City of Portland, Maine - Building or Use Permit Application

Permit No: 01-0455	Issue Date: MAY - 9 2001	CR#: 277 J011001
-----------------------	-----------------------------	------------------

BUILDING PERMIT REPORT

REASON FOR PERMIT: 4'6" x 10' mud room

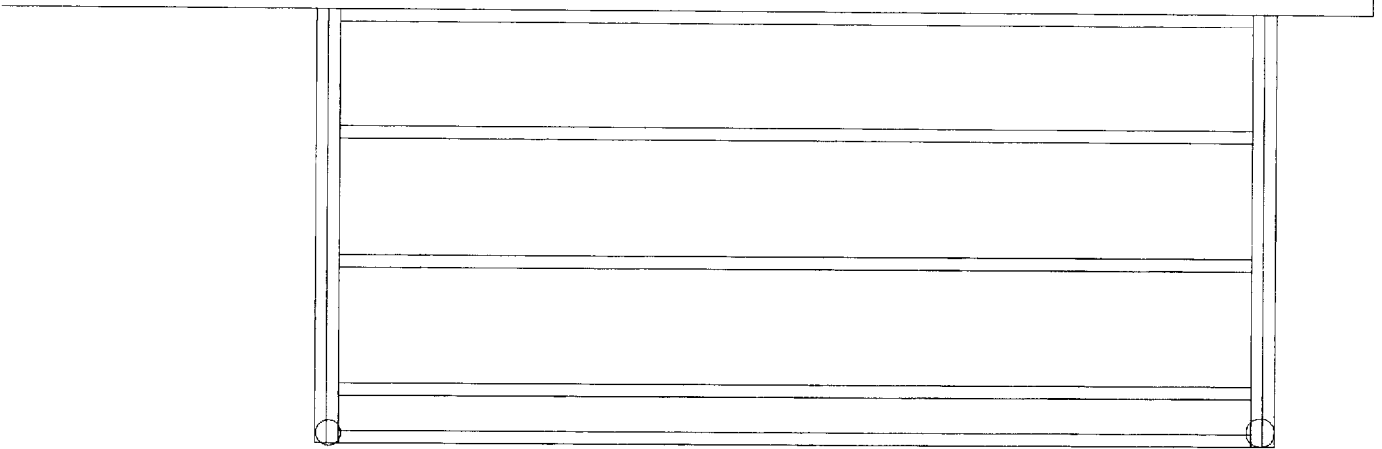
framing shall be 2x10 @ 16" o.c. ✓
floor to set on 2 10" tubes ✓
insulation 9" fiber glass + 1" foam
